Re: International Paper Company Comments  
Draft Augmented RI/FS Report  
Former Tacoma Metals Facility  
Tacoma, Washington

On behalf of International Paper Company (“International Paper”), URS Corporation (“URS”) has reviewed the *Draft Augmented Remedial Investigation and Feasibility Report* (February 2012) prepared by Kennedy/Jenks Consultants for Portland Avenue Associates, LLC c/o Eisenhower & Carlson, PLLC for the Former Tacoma Metals Site. International Paper does not oppose Alternative 2, the proposed cleanup alternative originally selected in the 2001 remedial investigation/feasibility study report (“RI/FS Report”). International Paper is however concerned that the draft augmented RI/FS Report contains inaccurate information regarding historic site uses, the locations of structures that are the sources of chemicals of concern (“COCs”), and the origin of COCs in the subsurface. This letter presents International Paper’s general comments on the above. More specific comments are presented in Attachment 1. To facilitate your review, proposed changes to the text are provided in italicized blue font. The general comments regarding the draft augmented RI/FS Report are as follow

**FIGURE 2**

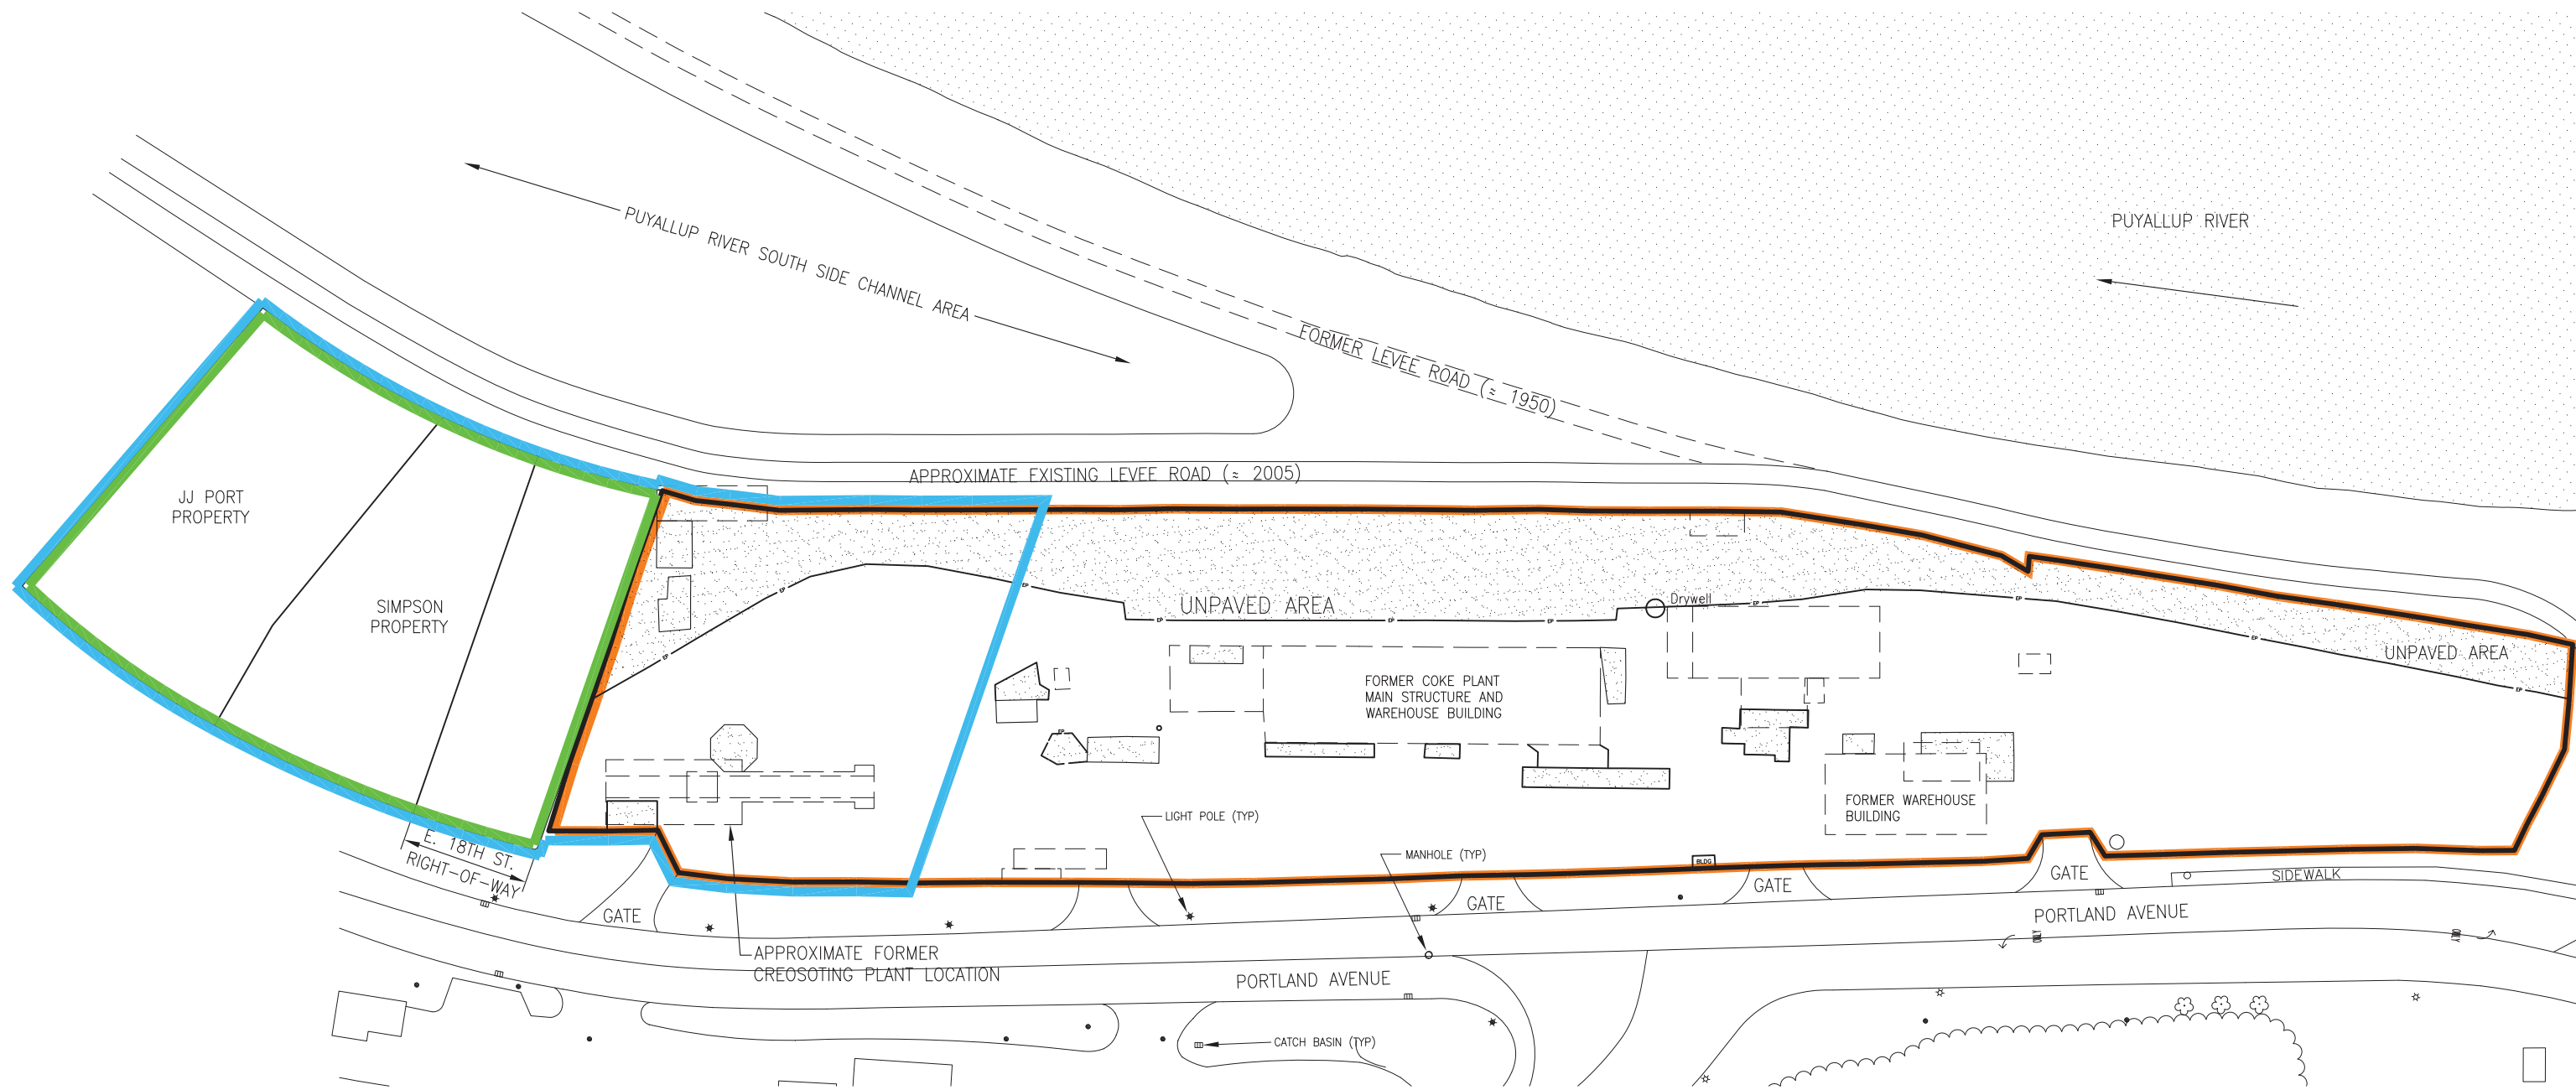
2. References to the former coke plant and other historical structures (including the former hexagonal AST identified on aerial photos and Sanborn fire insurance maps) should be included in text sections and on figures along with references to the former creosoting plant in the "Creosoting Plant Area." These various structures should also be discussed in text and shown on figures at different elevations corresponding to site grades appropriate for those structures. There appears to be a disproportionate evaluation of data presentation for the northern portion of the site (the Creosoting Plant Area) as compared to the southern half of

30. Figures 2, 3, 4, and 5 should be revised to include the location of former coke plant and other historical site structures (including the hexagonal AST) in the “Creosoting Plant Area” in addition to the former creosoting plant.

FIGURE 4

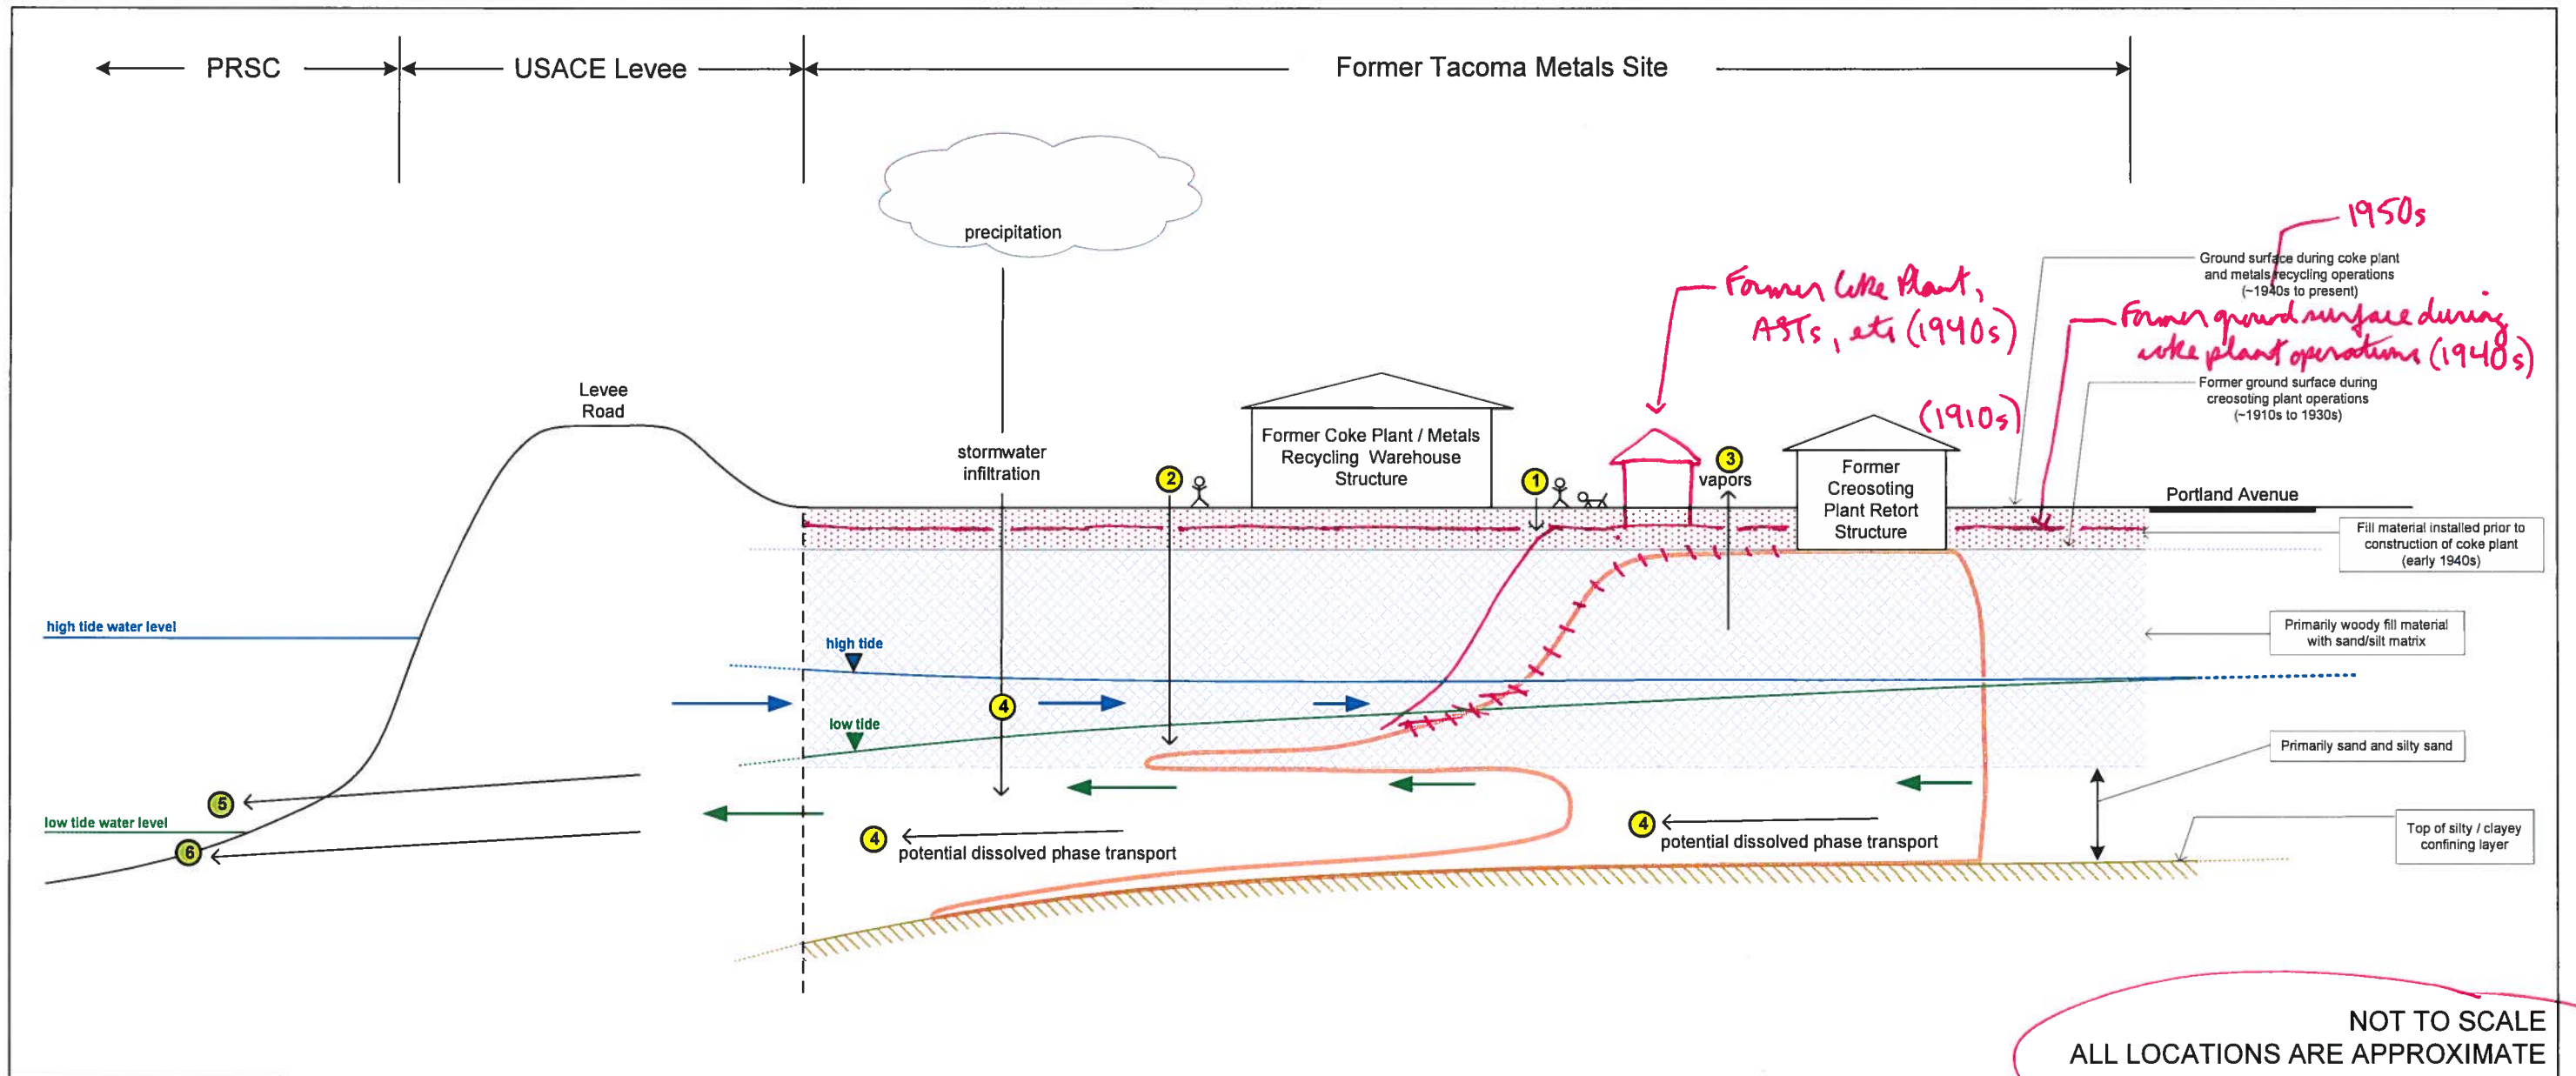
29. Section 5.2.3 Potential Exposure Pathways, page 5-5, second paragraph – “indicate the lateral migration of denser **creosote components** away from the former **creosoting plant location** the north and west along the upper surface of the fine-grained unit, as previously described (refer to Figure 4)” should be amended to “indicate the lateral migration of denser *COCs* away from the former *creosoting plant, coke plant, and other historical structure (e.g. hexagonal AST) locations* to the north and west along the upper surface of the fine-grained unit, as previously described (refer to Figure 4).”

31. Figure 4 should also be revised to the depths of those structures and to include migration pathways associated with historical site operations and observed contamination in addition to those shown for the former creosoting plant. The legend identifying “**Creosote-affected soil area**” should be amended to “*COC-*

- impacted deeper soil area.*” An additional surface (approximately 2 feet below the grade of Portland Avenue) should be added to identify the former ground surface at which former coke plant and other historical structure (e.g. hexagonal AST) foundations were identified. The current figure does not identify the intermediate fill layer upon which the coking operations were conducted, and does not show the structures (e.g. hexagonal AST) that existing while those coking operations were conducted.
